**SUSITNA  
HYDROELECTRIC PROJECT**

FEDERAL ENERGY REGULATORY COMMISSION  
PROJECT No. 7114

**ALASKA POWER AUTHORITY  
COMMENTS  
ON THE  
FEDERAL ENERGY REGULATORY COMMISSION  
DRAFT ENVIRONMENTAL IMPACT STATEMENT  
OF MAY 1984**

**VOLUME 2B  
TECHNICAL COMMENTS  
-AQUATIC RESOURCES**

OPTION?OPTION?

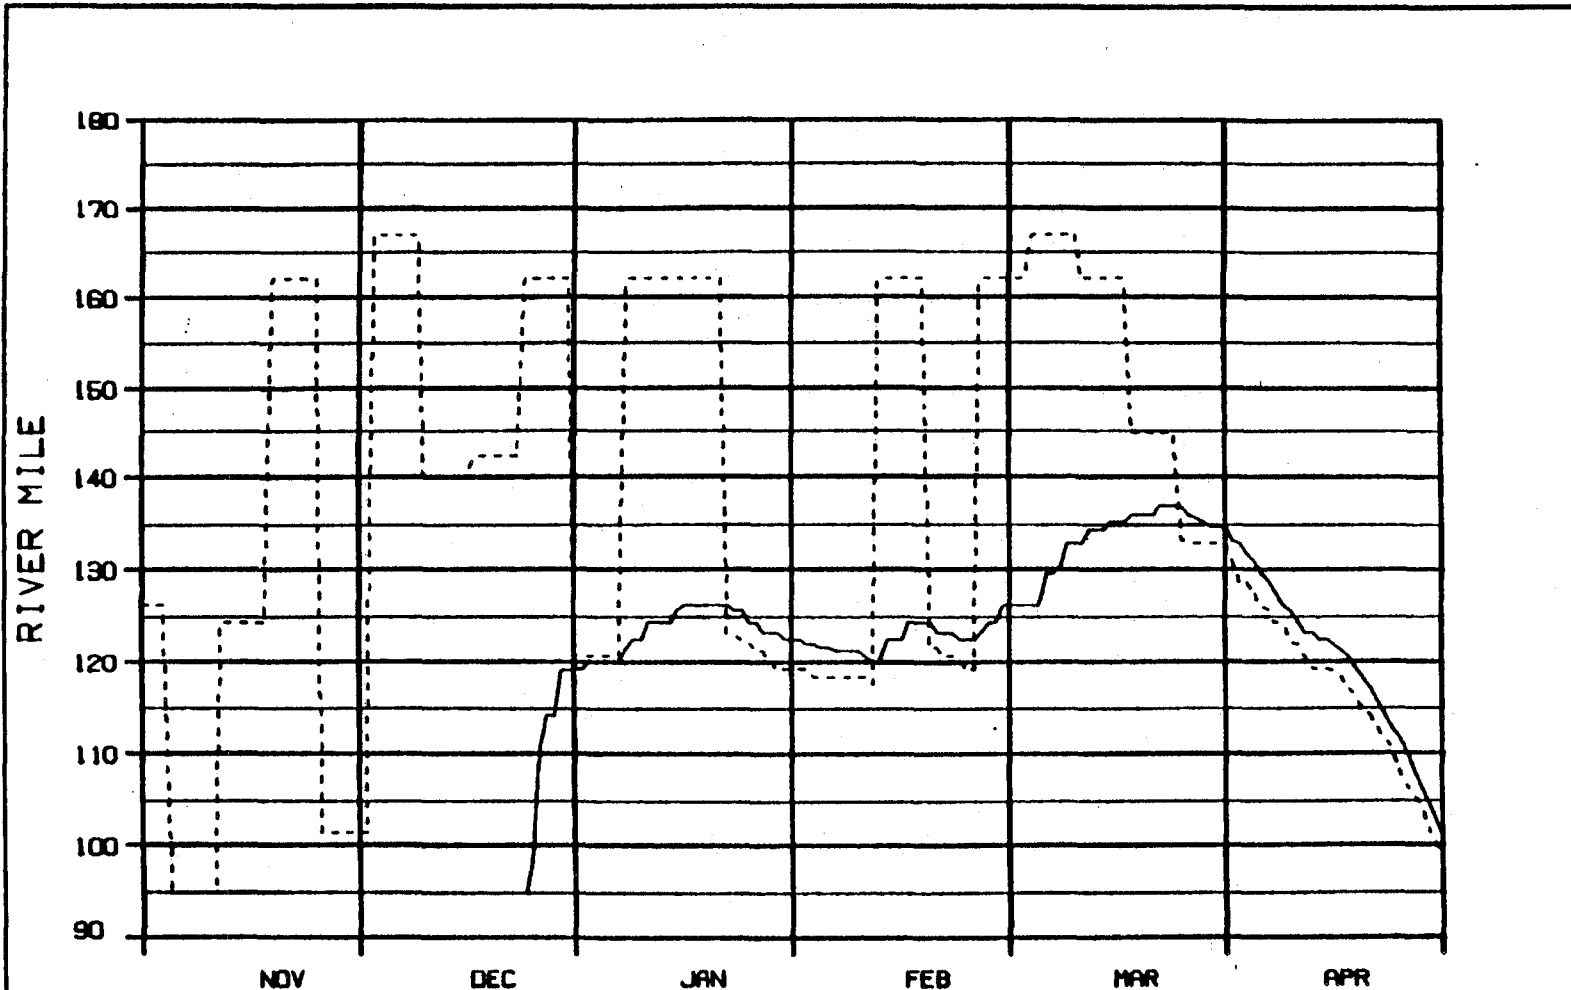
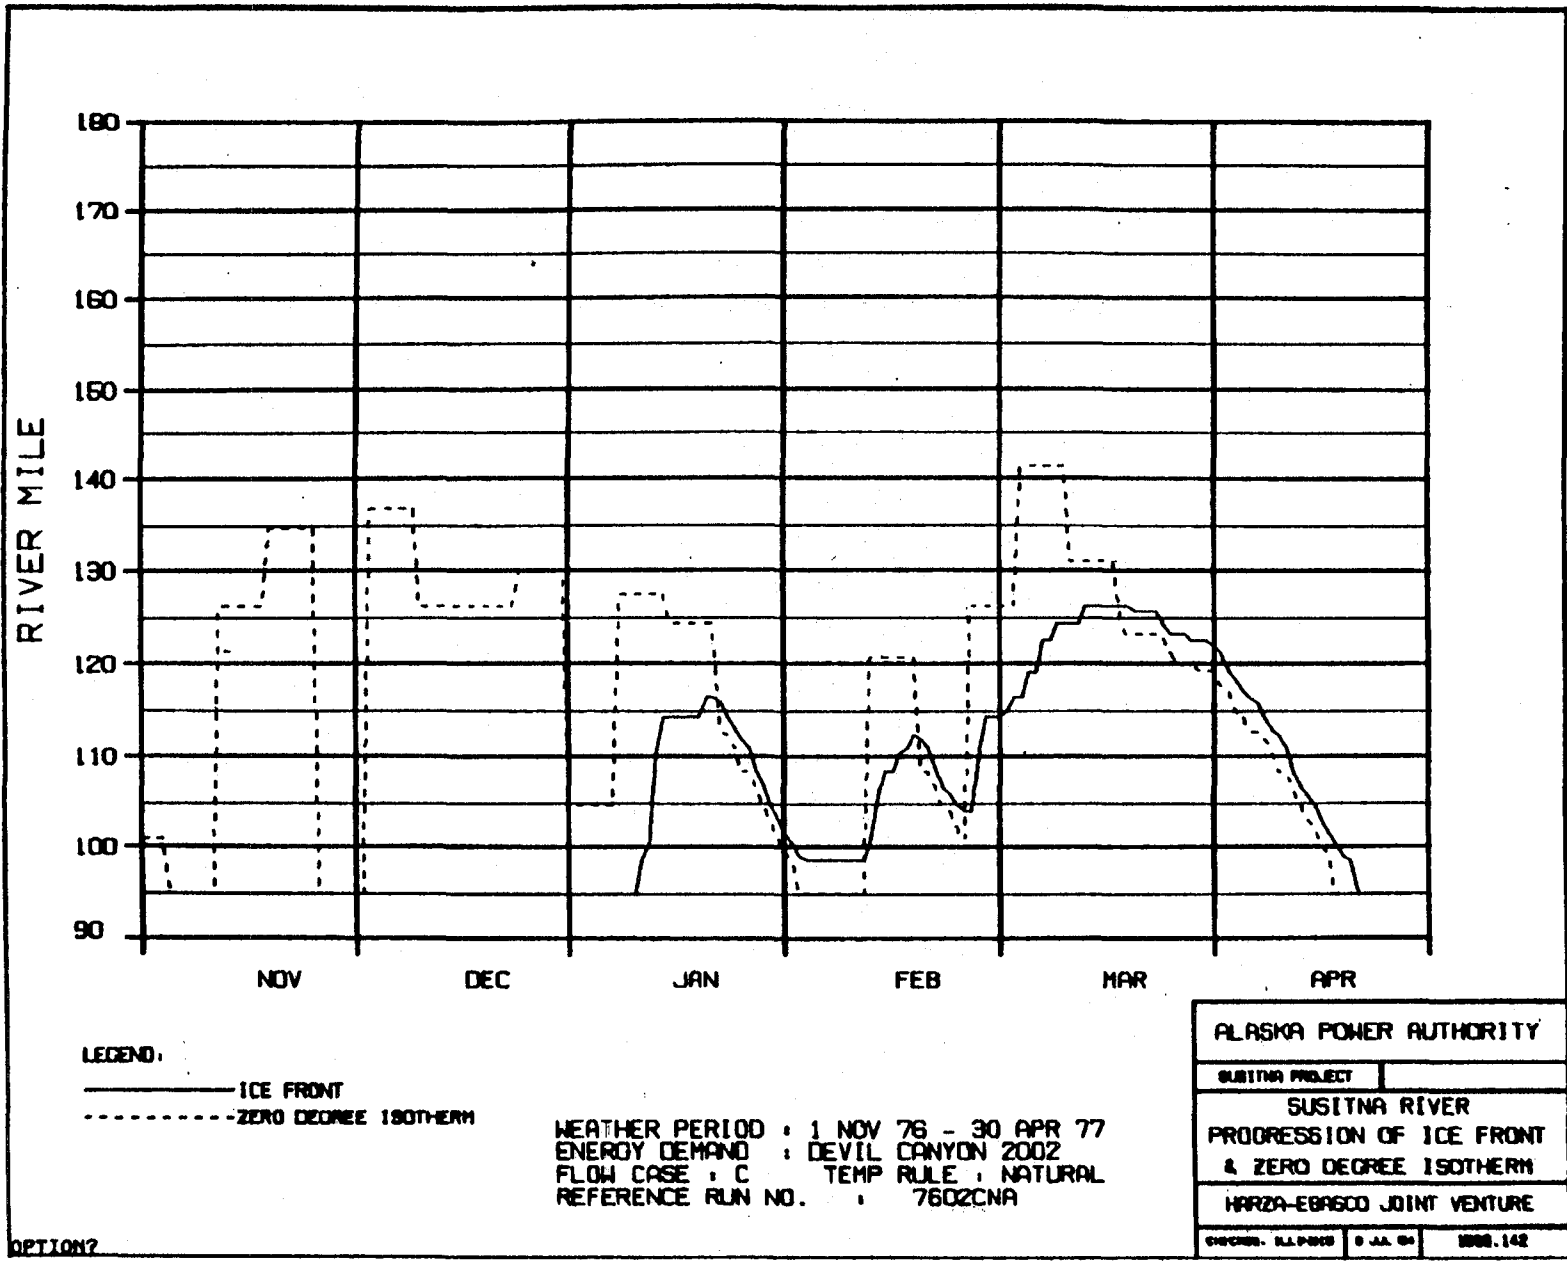
In cold winters such as 1981-1982, under natural conditions the ice front would be expected to reach Gold Creek in early January (Exhibit Q). With Watana only operating the ice front would advance to Gold Creek in late January (Exhibit G). With Devil Canyon operating the ice front would only advance to near River Mile 125, downstream of Slough 8A (Exhibit J).

The winter of 1971-1972 provided the fastest and furthest upstream progression of the ice front. For natural conditions the ice front would reach Gold Creek in mid-December (Exhibit O). With Watana only operating the ice front would reach Gold Creek in early to late January (Exhibits H and I) depending on the energy demand. With Devil Canyon operating the ice front would reach Gold Creek in early March for 2002 energy demands (Exhibit K). For Devil Canyon operating and 2020 energy demands the ice front would only advance to River Mile 133 (Exhibit L).

River ice simulations have also been made for the first and second winters of Watana filling. For the first winter when outflow would be made from the low level outlet and temperatures would be relatively warm the simulation was made using the 1982-1983 meteorological data which provide the mildest weather simulated. For this case the ice front would be expected to advance to near Gold Creek (River Mile 135) by mid-February. Maximum water levels would be similar to natural conditions. For the second winter of filling, outflows would be made from the midlevel outlet works (intake located at El. 2027), and outflow temperatures would be colder than in the first winter of filling. The winter of 1981-1982, a relatively cold winter was used to simulate river ice for this year. For this case the ice front would be expected to advance to near Gold Creek (River Mile 135) by early February (Exhibit N). For both the first and second winters of filling, border ice is expected to have a predominant influence on ice cover formation upstream of Gold Creek. This would be similar to natural conditions. Sufficient information was not available to allow accurate simulation of this process upstream of approximately River Mile 139 for the filling years.

The ice breakup (meltout) is expected to occur earlier with-project than under natural conditions. As indicated in Technical Comment AQR009 under natural conditions the river is generally open by mid-May. With-project the river upstream of the Chulitna-Susitna confluence may be open as early as mid-March for average winters such as 1982-1983 or as late as mid-May in very cold winters such as 1971-1972. With Devil Canyon operating with 2002 energy demands the river will generally be open 2 to 3 weeks earlier than with Watana only operating. With Devil Canyon operating and 2020 energy demands, the river upstream of the Chulitna-Susitna confluence would be open 2 to 3 weeks earlier than with 2002 demands. For filling of Watana reservoir the river would probably be open in mid-May similar to natural conditions.

With-project the ice is expected to be removed from the middle reach by meltout rather than breakup. The melting occurs generally before solar radiation becomes important. The melting is accomplished by above 0°C water reaching the ice front when air temperatures are not low enough to cool the reservoir outflow to 0°C.

The with-project meltout will generally take place over a longer time period than pre-project breakup. Exhibits A-R show meltout occurring in 2-4 weeks, whereas pre-project breakup generally occurs in 1-2 weeks.

Figure 1: Hypothetical Relationship between Mainstem Discharge and Total Wetted-Surface Area in a Slough

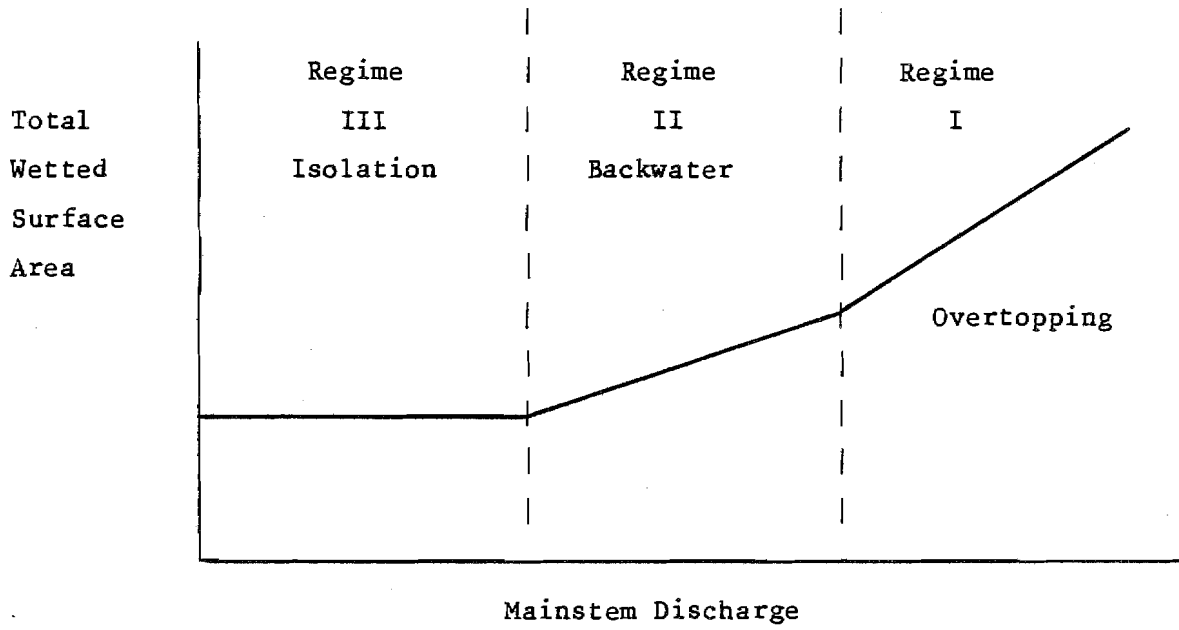
Evaluation of the effects of with-project discharge on total wetted-surface areas in sloughs as presented on page DEIS H-37 is dependent upon using an appropriate data base. To determine the appropriateness of the data base to be used to determine percent change in wetted-surface area, the data should conform to a basic premise describing the relationship between mainstem discharge and the wetted-surface area of the sloughs. The effect of mainstem discharge on wetted-surface areas in sloughs is shown schematically in the attached Figure 1.

The results presented in Table H.3-6 indicate that the wetted-surface area of Slough 21 decreases with mainstem discharge from 20,000 cfs to 12,500 cfs. Based on the relation presented in Figure 1, such a decrease would not be expected. The principal reason for the apparent discrepancy is that the study area encompassed by the wetted areas presented in Table H.3-6 include both a portion of Slough 21 and a portion of the side channel complex downstream from the mouth of the slough (ADF&G 1983a, Appendix Plate E-1 delineates the study boundaries for the surface area measurements). Because of the inclusion of some side channel area, conclusions reached pertaining to loss of wetted-surface areas in sloughs are not completely substantiated.

Figure 2. CHUM SALMON NOMOGRAPH

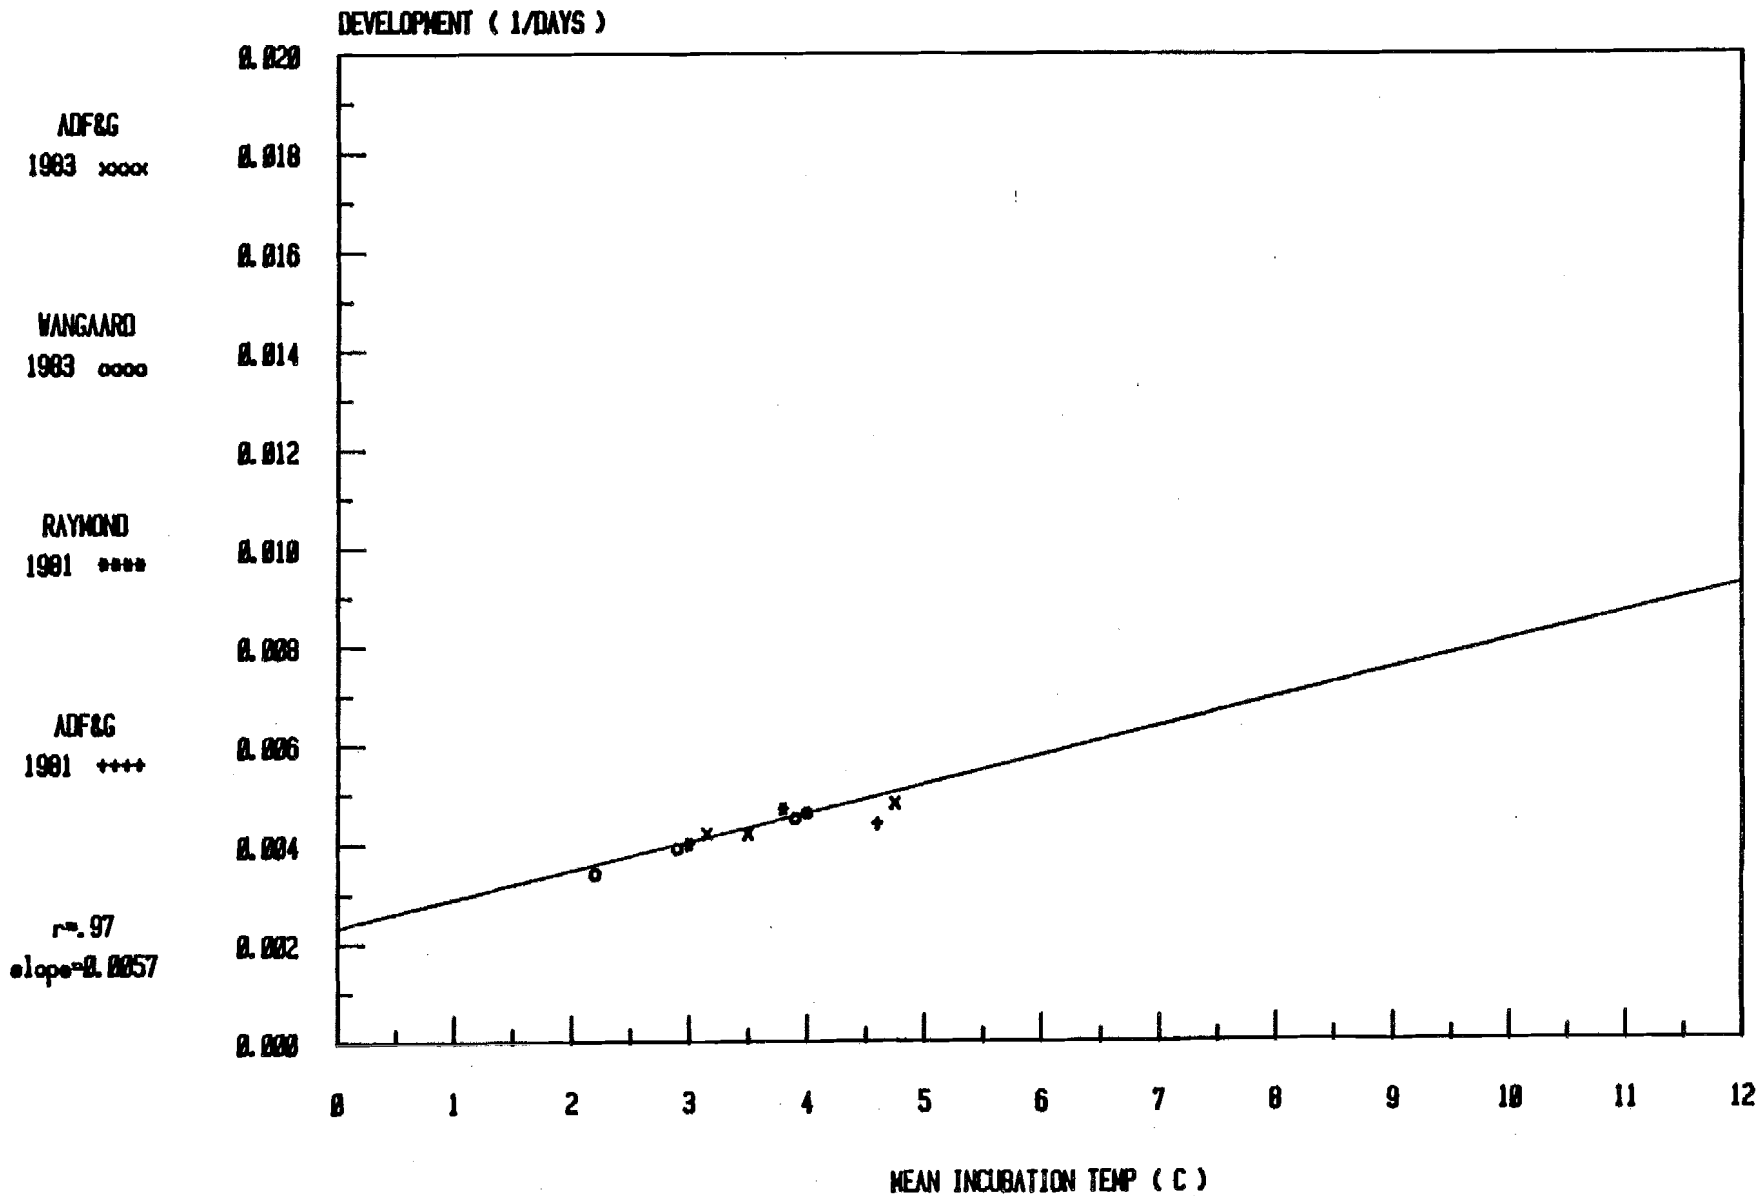
The calculated regression can give an approximate estimate of incubation time. A simplified way of estimating emergence time is to make a nomograph from the development time graph (Figure 2 attached). If the spawning date and average incubation temperature are known, the approximate emergence date can be calculated. For example, chum salmon spawned on September 1 at an average incubation temperature of 3°C would emerge between May 1 and 10. Mean incubation temperatures for the four primary spawning Susitna sloughs ranged from 2.0 to 4.3°C (ADF& G 1983f). Predicted natural mainstem mean temperatures during the incubation period under average climatological conditions was around 1.2°C (Figure 3 attached). Referring to the nomograph (Figure 2) using a spawning date of September 1 at 1.2°C would show fish emerging much later than June 10. This would be too late to assure a viable population and indicates that temperature is a limiting factor in the mainstem under natural conditions. Predicted mainstem temperatures under

Figure 3. Predicted Susitna River temperatures °C September - April  
1982-83 Meteorology & Hydrology

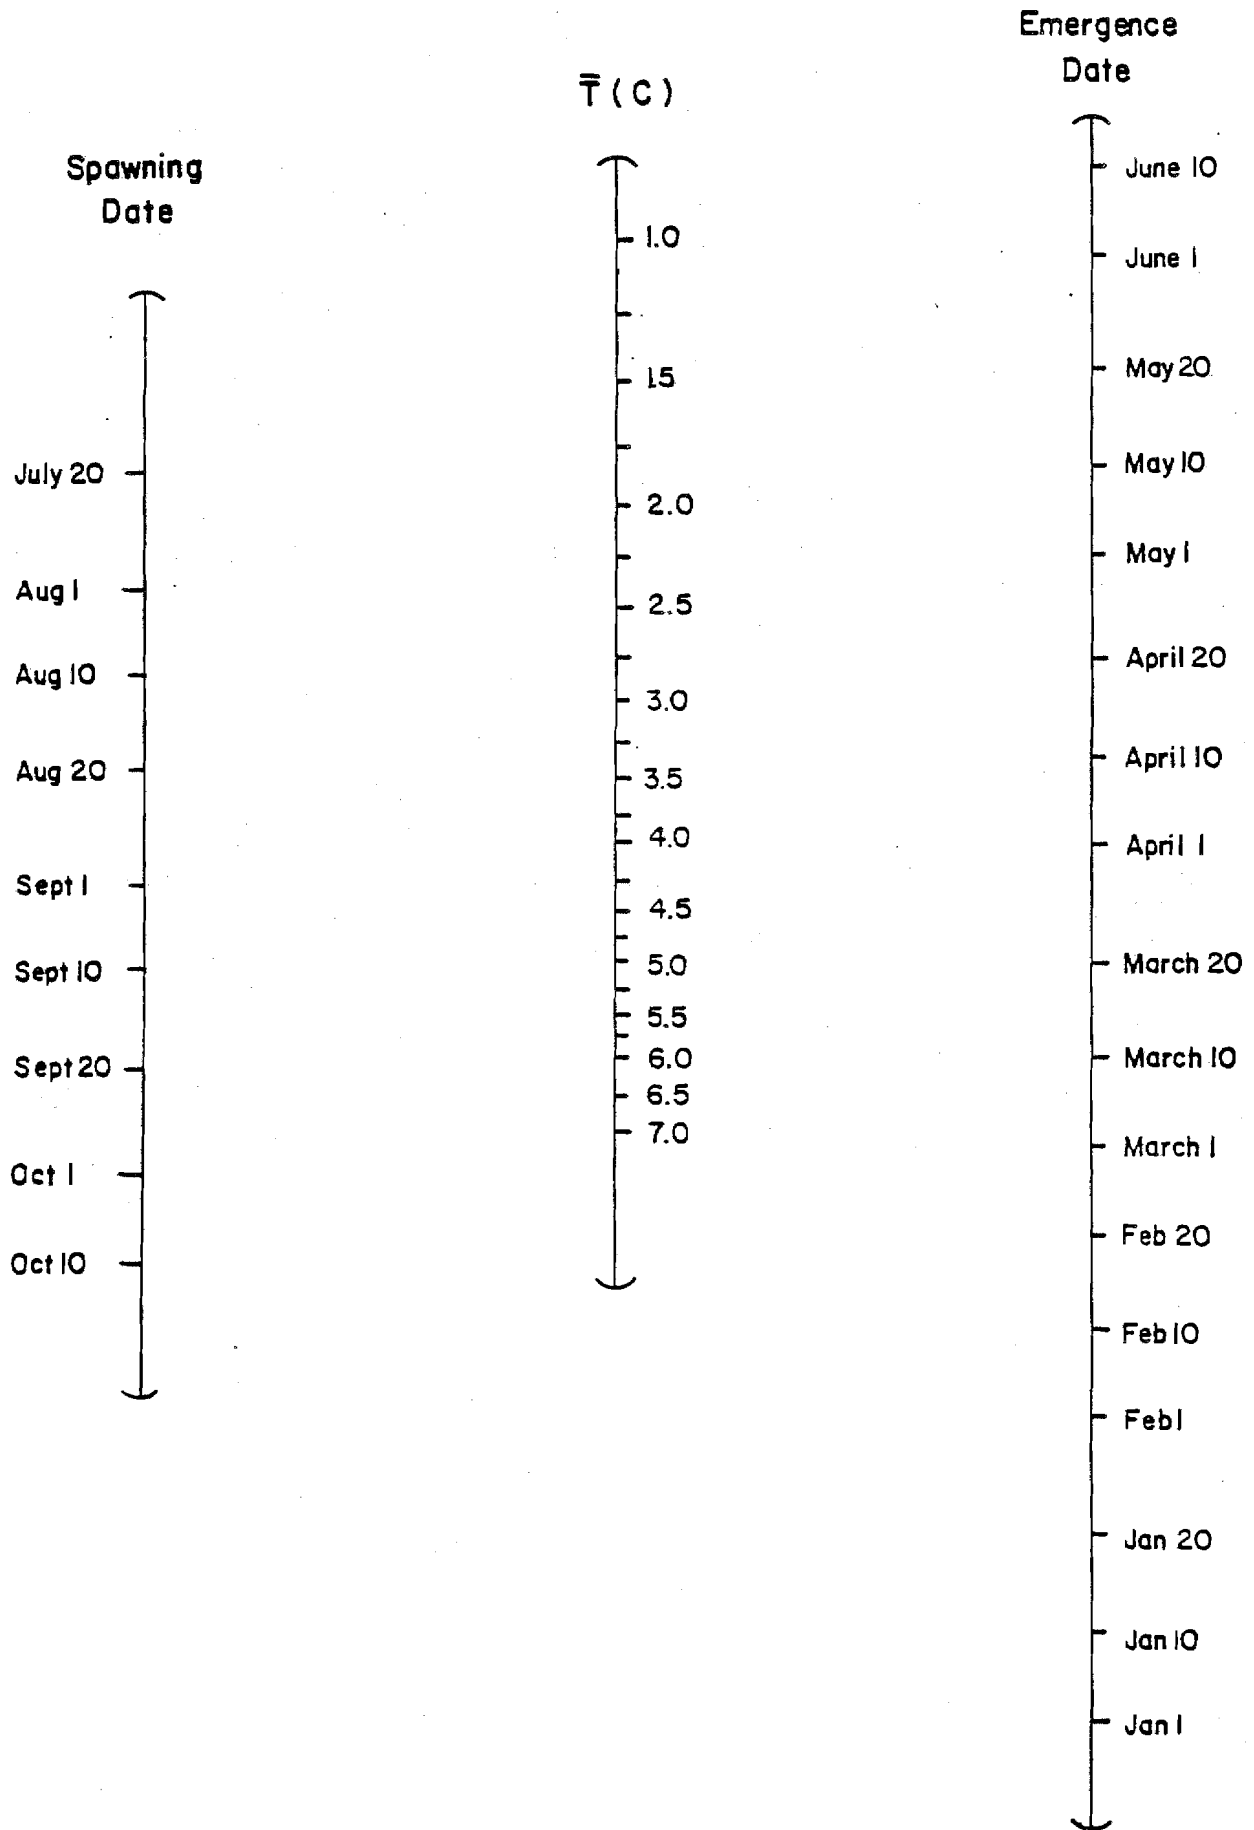
the one and two-dam scenarios (Figure 3) approach that recorded in the successful slough spawning areas and fish spawned on September 1 would emerge in late May.
